RE: PLUM Agenda Item #11 May 17th 2022  
Re: Council Files Nos. 21-0829 and 21-0829S1

**BUREAU OF ENGINEERING**  
**MEMORANDUM**  
**TENTATIVE SUBDIVISION MAP REPORT**

Subdivision Map No: VTT82288  
Date: December 23, 2019  
Location: Between North Venice Boulevard and  
South Venice Boulevard, and between  
Pacific Avenue and Dell Avenue  
CD: 11 WLA#: 1618 District Map: 106-5A145

**South Venice Blvd (N/S), looking Easterly.**

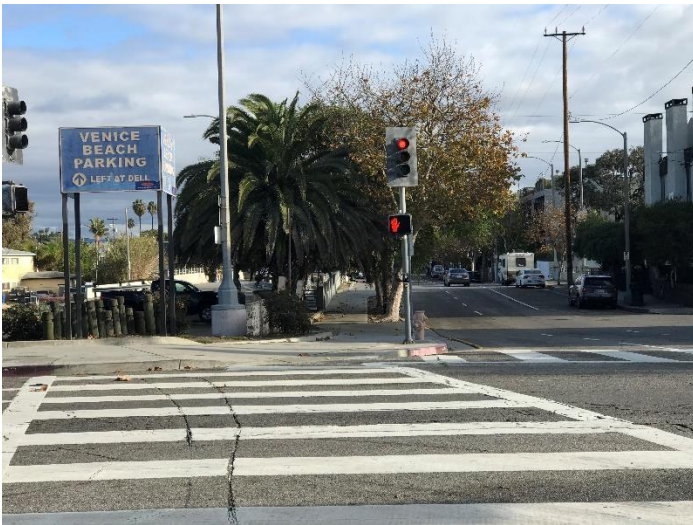
Dedication: Dedicate 20-ft wide along property frontage to encompass existing street improvement including roadway and boarder. Dedicate extra 6-ft (26-ft total) where the existing stairs are constructed for access to Canal Street sidewalk. Dedicate extra 11-ft (total 31-ft) where the existing left hand turn lane is constructed at West of Dell Avenue. Submit dedication plan to WLA BOE for review and approval.

Improvement: Remove existing sidewalk and construct full width concrete sidewalk to abut both the new property line and curb. Close unused driveway. Remove and replace any broken, damaged, or off grade adjacent pavements and integral concrete curb and gutter per the City and ADA standard. Remove existing access ramp at Northeast corner of South Venice Boulevard and Pacific Avenue intersection, and Northwest corner of South Venice Boulevard and Dell Avenue intersection and construct new ADA access ramps according to the current City standard plan S-442. Install new street trees and tree wells with root barriers to the satisfaction of the Urban Forestry Division of the Bureau of Street Services. All these improvements shall transition suitably and shall be constructed to the satisfaction of the City Engineer per B-permit.

Pacific Ave (E/S), looking northerly.

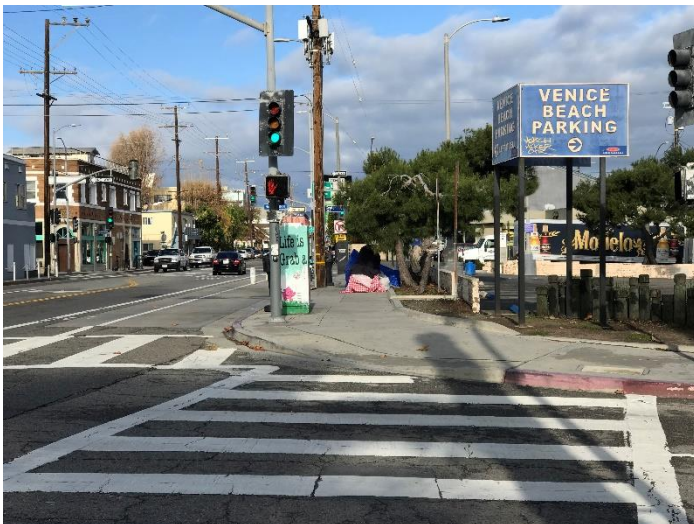
Dedication: Dedicate 20.5-ft along frontage to complete 43-ft wide standard half right-of-way for the Avenue II. Also, two corners, at Pacific Avenue and North Venice Boulevard, and Pacific Avenue and South Venice Boulevard need to be dedicated for 20-ft radius corner dedication.

Improvement: Remove existing 10-ft wide sidewalk and construct new full width concrete sidewalk abutting new property line after dedication. Remove and replace any broken, damaged, or off grade adjacent pavements and integral concrete curb and gutter per the City and ADA standard. Remove existing access ramps at Southeast corner of North Venice Boulevard and Pacific Avenue, and Northeast corner of South Venice Boulevard and Pacific Ave and construct new ADA access ramps at the corner according to the current City standard plan S-442. Install new street trees and tree wells with root barriers to the satisfaction of the Urban Forestry Division of the Bureau of Street Services. All these improvements shall transition suitably and shall be constructed to the satisfaction of the City Engineer per B-permit.

Canal St (E/S), looking Southerly

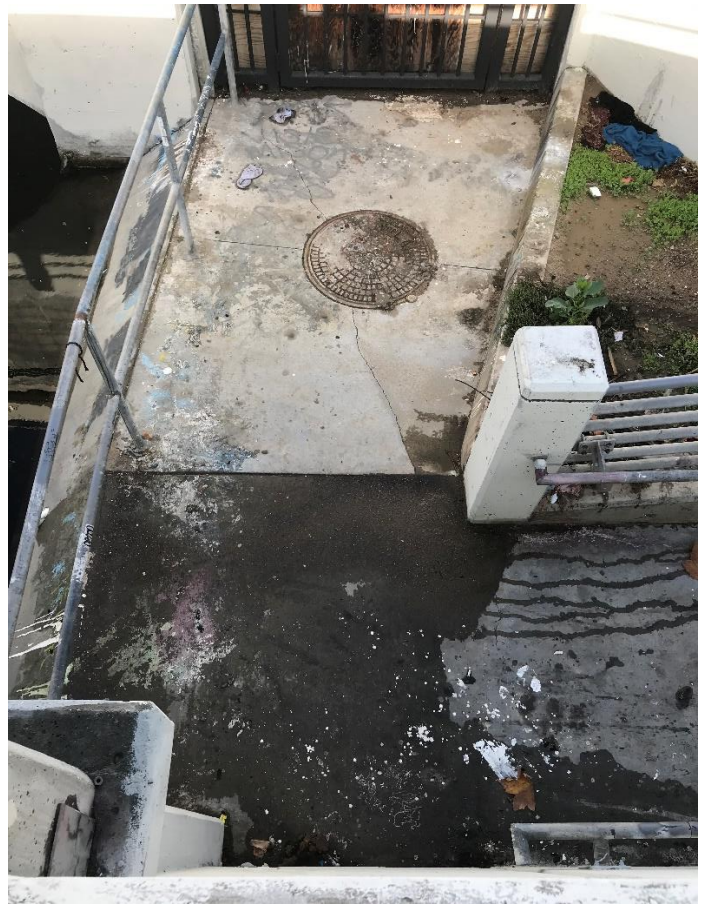
Dedication: The bridge over Canal Street will only be used by the subject property and does not provide access to the public. Dedicate sufficient easement area for the City maintenance crew and vehicles to access the bridge for maintenance and necessary repair. Submit new map to show proposed easement for the City crew access.

Improvement: Remove and reconstruct existing 6-ft wide sidewalk along the canal water way on both sides per current City standard and ADA standard. Replace any broken or off grade adjacent pavements, retaining walls, and guard rails. Install new street trees with root barriers to the satisfaction of the Urban Forestry Division of the Bureau of Street Services. All improvements shall transition suitably and shall be constructed to the satisfaction of the City Engineer per B-permit.

Dell Ave (W/S), looking Northerly.

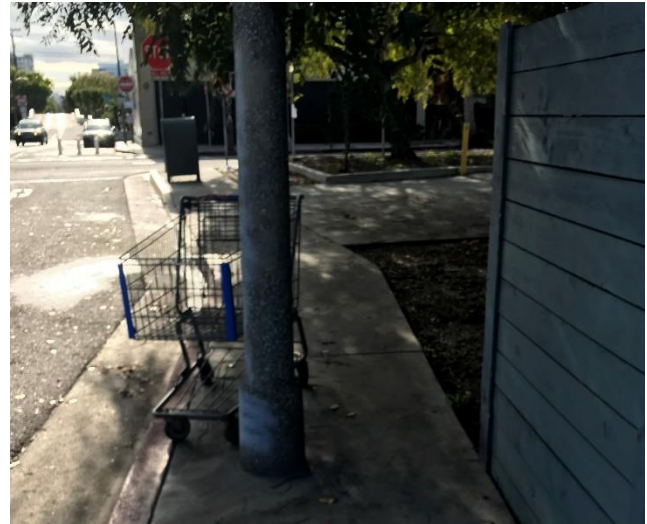
Dedication: Dedicate 10-ft along the property street frontage to complete 30-ft wide standard half right-of-way for the local street. Also, dedicate a 20-ft property line radius corner at intersection with South Venice Boulevard.

Improvement: Remove existing 4.5-ft wide sidewalk and construct a new 5-ft wide concrete sidewalk abutting the new property line. Close unused driveway. Remove and replace any broken, damaged, or off grade adjacent pavements and integral concrete curb and gutter per the City and ADA standard. Remove existing access ramp at North West corner of South Venice Boulevard and Dell Avenue and construct a new ADA access ramp according to the current City standard plan S-442. Install new street trees with root barriers to the satisfaction of the Urban Forestry Division of the Bureau of Street Services. All these improvements shall transition suitably and shall be constructed to the satisfaction of the City Engineer per B-permit.
